ADDENDUM NO. 2

PROJECT: Hickory Woods Park Phase 1B Improvements

OWNER: Pittsfield Charter Township

DATE: March 9, 2011

A2-SK-01

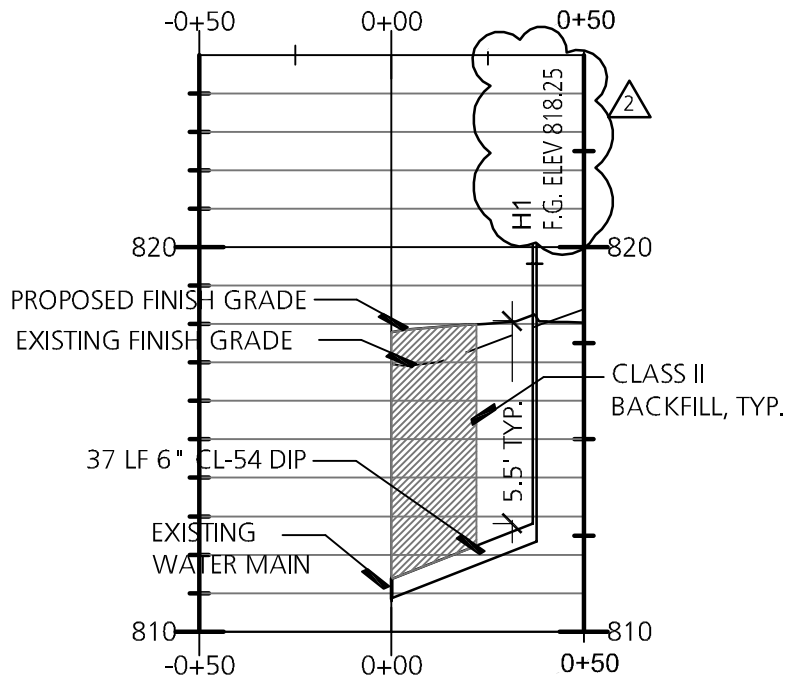
AD2-1: Sheet S-10 (See Sketch A2-SK-01)
Revised utilities inverts and rim elevations.

STRUCTURE SCHEDULE

STRUCTURE	TYPE	INVERTS
ES 1	FLARED END SECTION	14"x 23" S 816.25
ES 2	FLARED END SECTION	14"x23" N 816.10
ES 3	FLARED END SECTION	12" S 817.00
ES 4	FLARED END SECTION	12" N 816.80
ES 5	FLARED END SECTION	18"NW 822.75
ES 6	FLARED END SECTION	12" SE 813.00
ES 7	FLARED END SECTION	12" NW 812.50
ES 8	FLARED END SECTION	12" S 817.26
ES 9	FLARED END SECTION	12" N 817.00
ES 10	FLARED END SECTION	12" SE 812.11
ES 11	FLARED END SECTION	12" NW 812.01
ES 12	FLARED END SECTION	12" SE 820.50
ES 13	FLARED END SECTION	12" NW 809.19
ES 14	FLARED END SECTION	12" NE 816.69
ES15	FLARED END SECTION	12" N 816.55
STR 1	4' DIA. MH (RIM - 827.00)	18" NW 823.55 18" SE 823.55
STR 2	2' DIA. INLET (RIM - 824.40) 1040Z, TYPE 02, BEEHIVE CASTING	12" SE 821.00 6" NW 821.20
STR3	2' DIA. INLET (RIM - 813.01) 1040Z, TYPE 02, BEEHIVE CASTING	12" SE 809.44 6" NW 809.61
STR4	OUTLET CONTROL STRUCTURE (RIM - 818.39)	12" SW 816.80
CO1	6" CLEANOUT (RIM 825.00)	6" SW 818.86 6" NE 818.86

CO2	6" CLEANOUT (RIM 826.35)	6" SE 819.27
SAN1	4' DIA. MH (RIM - 811.60)	6" S 806.77 6" W 806.97
SAN2	4' DIA. MH (RIM - 816.28)	6" E 810.47 6"W 810.57
SAN3	4' DIA. MH (RIM - 818.39)	6" E 814.07 6"W 814.27
SAN4	4' DIA. MH (RIM - 824.00)	6" E 817.76 6"SW 817.96
H 1	FIRE HYDRANT	F.G. ELEV. 818.25
